# UNITED STATES PATENT AND TRADEMARK OFFICE

APPLICATION NO.	FILING DATE	FIRST NAMED INVENTOR	ATTORNEY DOCKET NO.	CONFIRMATION NO.
10/601,573	06/24/2003	Seung-Jae Lee	1293.1798	8257
21171	7590	04/15/2005	EXAMINER	
STAAS & HALSEY LLP			COLILLA, DANIEL JAMES	
SUITE 700				
1201 NEW YORK AVENUE, N.W.			ART UNIT	PAPER NUMBER
WASHINGTON, DC 20005			2854

<b>Office Action Summary</b>	Application No.	Applicant(s)
	10/601,573	LEE, SEUNG-JAE
	Examiner Daniel J. Colilla	Art Unit 2854

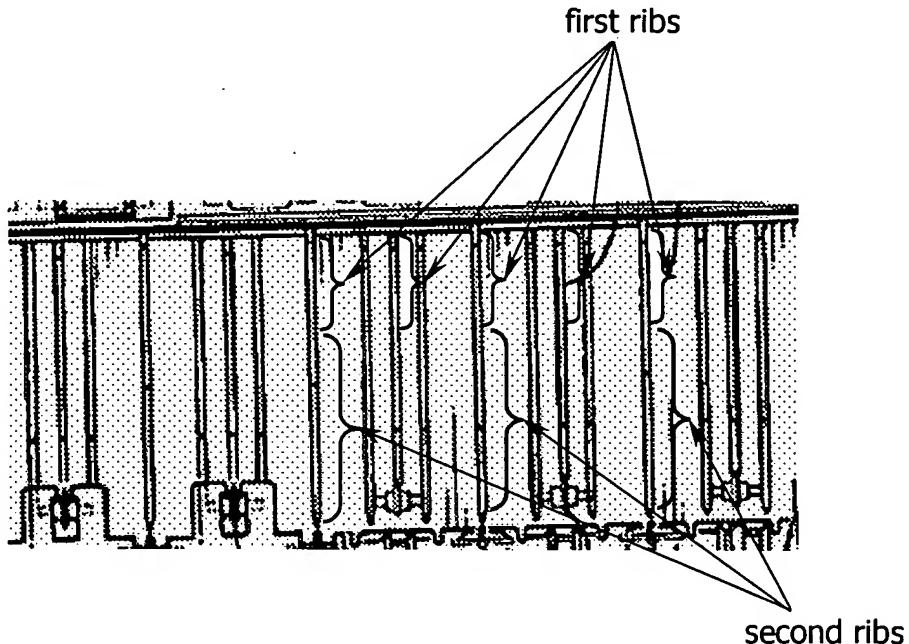
With respect to claim 1, Samoto et al. discloses a paper guide including a plurality of first ribs and second ribs as shown below in the Figure taken from Figure 6 of Samoto et al.:

The first ribs are the first half of the ribs 256 and 258 as shown above. The second ribs are the second half of ribs 258. The interval between the first ribs is equal as shown above and the interval between the second ribs is equal as well, and the interval between the second ribs is wider than the interval between the first ribs. This definition of first and second ribs appears to be a reasonable interpretation of Samoto et al. given applicant's definition of first and second ribs. Additionally, Figure 9 of Samoto et al. shows that the first ribs are located under a front half swath of printhead 112 and the second ribs are located under rear half swath of printhead 112. Furthermore each of the second guide ribs is connected to a corresponding first guide rib as shown above.

With respect to claim 2, the first and second guide ribs are linearly connected to one another as shown in Figure 6 of Samoto et al.

With respect to claims 3 and 6, the second to left bracketed first guide rib in the above Figure is between first guide ribs connected to second guide ribs.

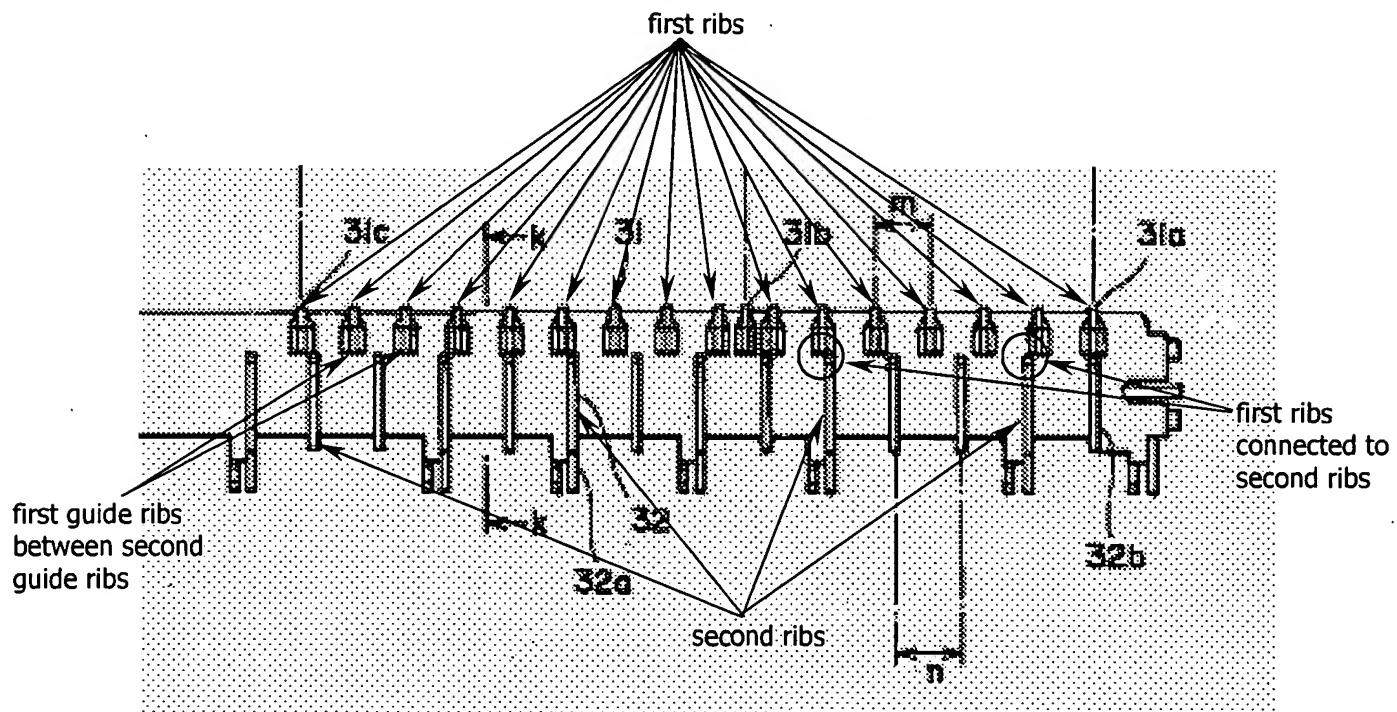
With respect to claim 1, Kanemitsu discloses a paper guide 30 including a plurality of first guide ribs 31 and a plurality of second guide ribs 32 as shown below in the Figure taken from Figure 2 of Kanemitsu:

As can be seen in the Figure, the spacing between the ribs designated as a first ribs is equal and the spacing between the second ribs designated as second ribs is equal. And the interval between the second ribs is wider than the interval between the first ribs.

With respect to claim 2, Kanemitsu discloses that the second ribs are linearly connected to the first ribs as detailed in the above Figure and shown in Figure 1 of Kanemitsu.

With respect to claim 3, the above Figure shows multiple first guide ribs between the first guide ribs that connect to second guide ribs.
